Clarification on Partial Frames and LPI

Partial Frame Coupling

Figure 149-XXX Timing relationship to PFC24

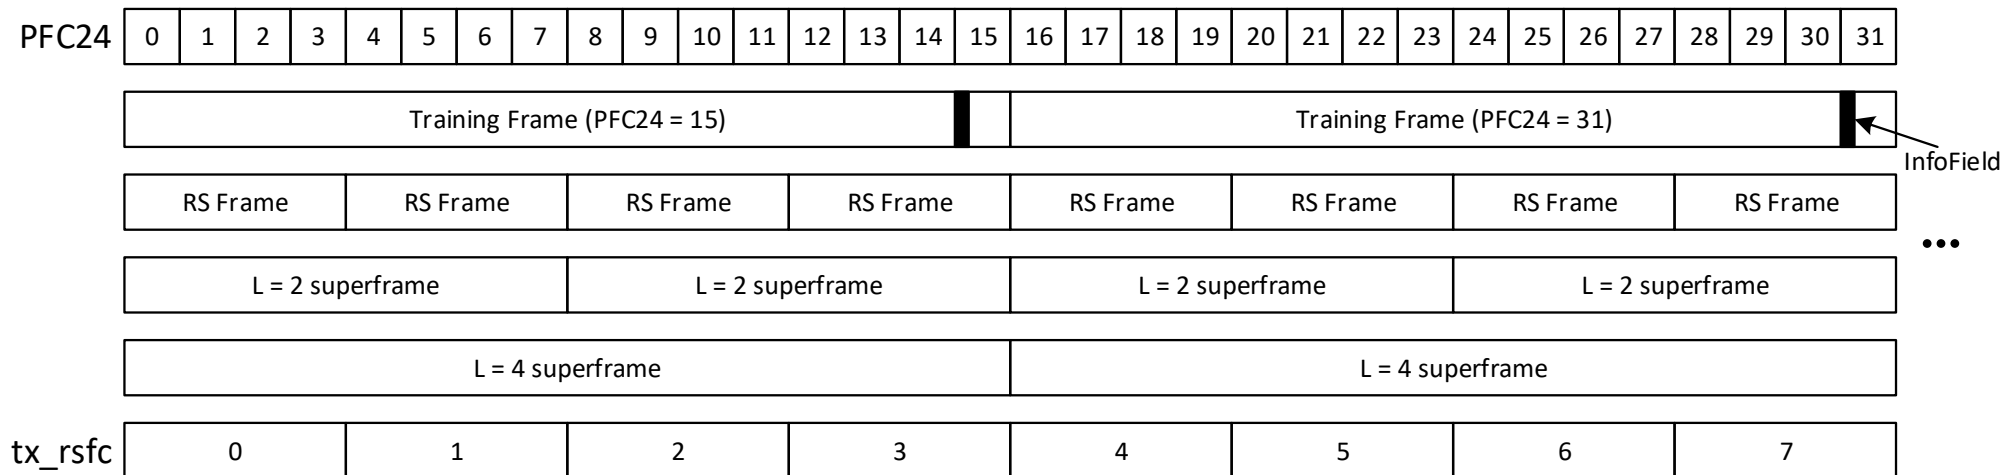
- 149.3.4.1 defines the partial frame and its relationship to the training frame. The training frame's relationship to other items are scattered throughout the document.
- tx_rsfc is not rigorously defined but used in 149.3.5.1
- Following slide shows some clarifying text to put everything in one place

- Page 98 line 35 – add the following text

The timing relationship among training frame, partial frame, RS frame, superframe, PFC24, and tx_rsfc are shown in Figure 149-XXX.

- Page 98 line 41 – add the following figure

Figure 149-12—Timing periods for LPI signals

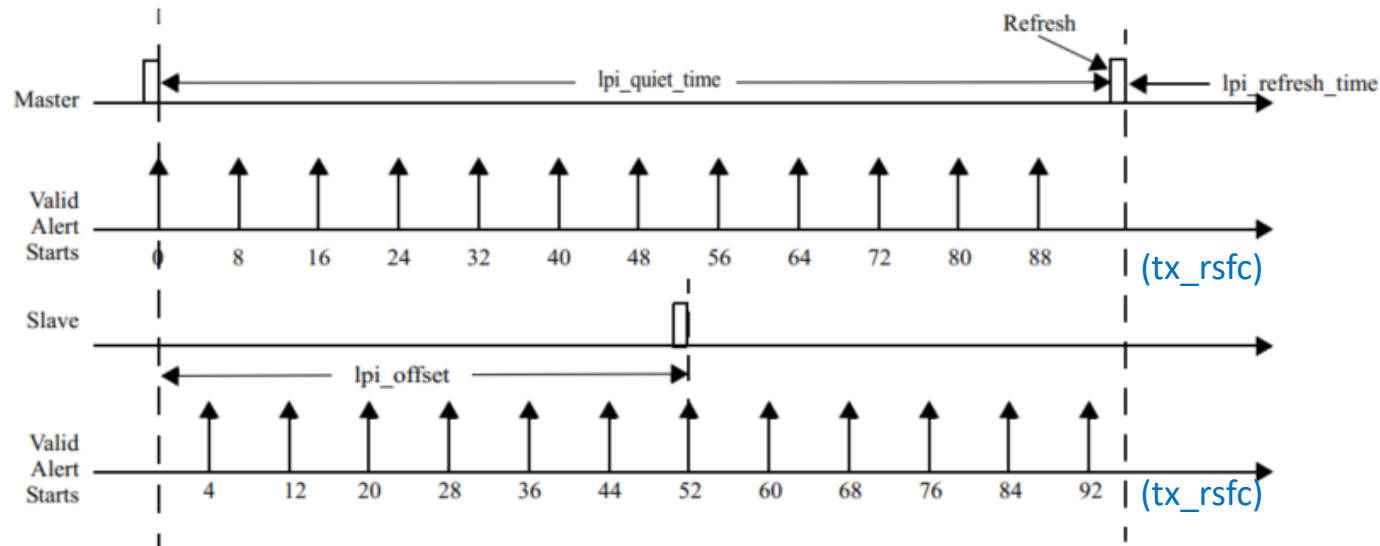
- The term RS-FEC frame periods in 149.3.5 accurately describes the relative timing among the LPI elements (quiet, refresh, offset, etc) but does not clearly describe the absolute timing relationship between these elements and partial frames.
- Following slides show some clarification

- Insert the tx_rsfc labels in Figure 149-12 to clarify what the numbers mean
